PROPOSED CHANGE NO. 2

SOUTHWEST EXPERIMENTAL FAST OXIDE REACTOR

Re: LICENSE DR-15

Proposed Change No. 2
for the
Southwest Experimental Fast Oxide Reactor

FIG. 1: AMOUNT OF SODIUM LOST VS. LEAK RATE,
FOR 15 GALLON NET CHANGE IN REACTOR VESSEL SODIUM CONTENT.

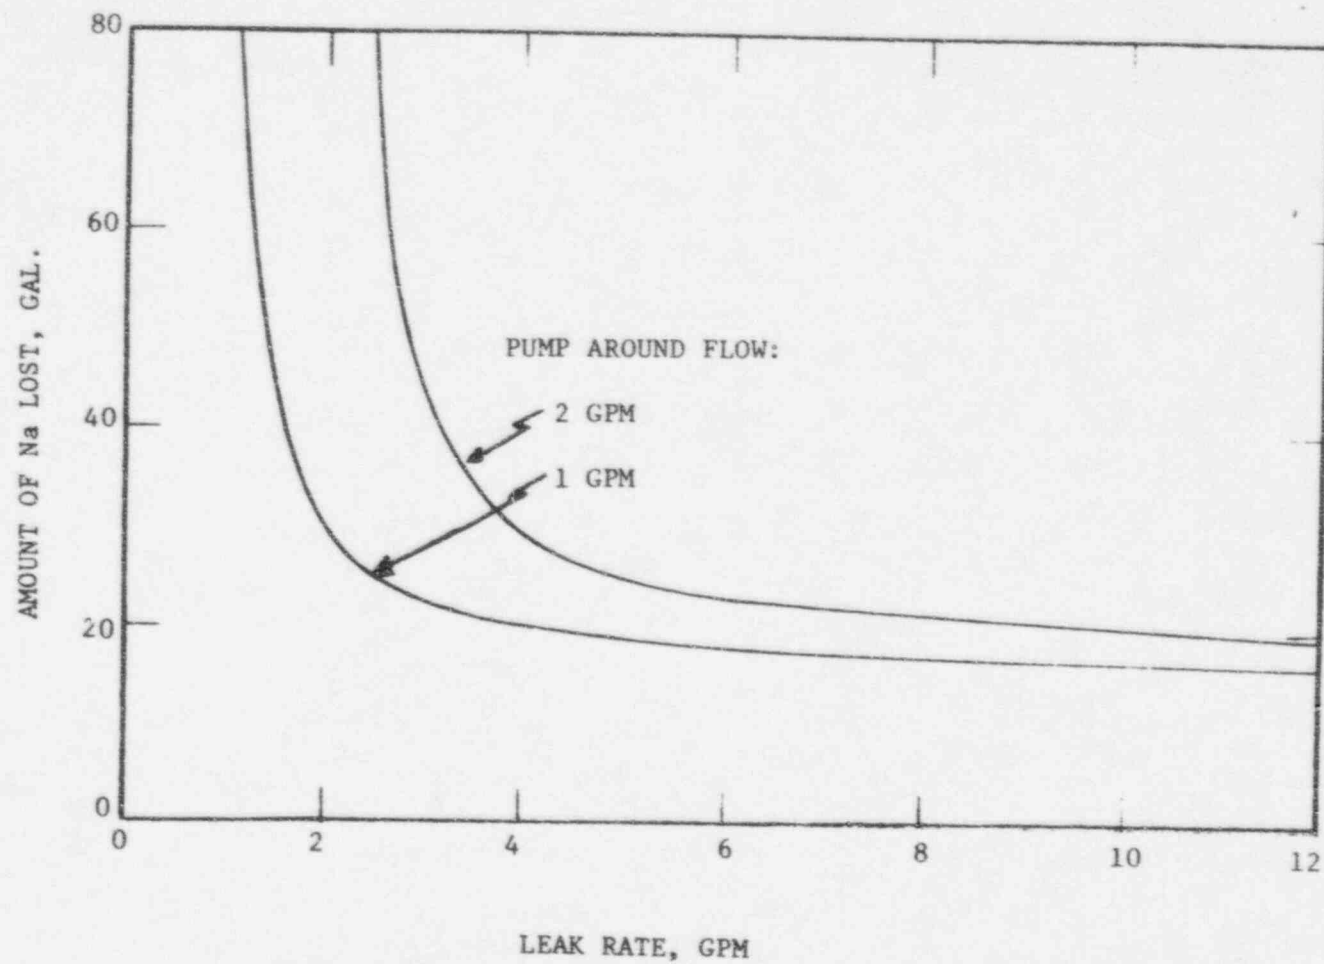
This change has a relatively small effect on protection afforded by the low sodium level probes. For leak rates significantly higher than the pump-around flow rate, the amount of sodium lost before detection occurs increases slightly when the allowable flow rate is increased to 2 gpm as indicated by Figure 1. This same figure shows that a larger change occurs over a narrow range of leak rates, from about 1-1/2 gpm to about 3-1/2 gpm. Protection against sodium leaks in this range and at rates below the pump-around flow rate is provided by the Na-24 monitor.⁽²⁾

To alleviate this situation, it is proposed that the allowable pump-around flow rate be increased from 1 gpm to an average value of 2 gpm. Operational tests on the system have indicated that a nominal value of 2 gpm is the lowest flow rate at which the system can be operated and still eliminate the large number of spurious low flow alarms that have been experienced to date. Operational safety would be improved by elimination of numerous alarm signals which tend to divert the operator's attention, and through more stable operation of the pump-around-pump.
